E1.20 Review 3.1

Notes from the chair.

46 Section 10.6.4

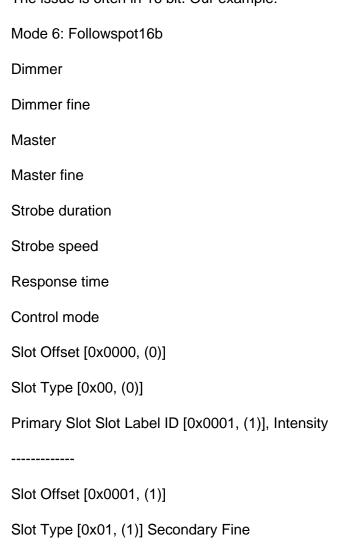
Comment:

We wanted to show the issue as RDM Integrity shows it as a lot of manufacturers are using this test tool. Unfortunately RDM Integrity is wrong when you have a 16 bit slot and it creates a lot of issues. Even for us it is difficult to explain clearly what to do. The standard in this occasion uses words and table that are misleading and many controllers fell into the trap. The issue is often in 16 bit. Our example:

Resolution: Accept:

- Table C1 change ST_SEC_INDEX to ST_SEC_QUANTUM
- Table C1 change ST_SEC_INDEX_ROTATE to ST_SEC_QUANTUM_ROTATE
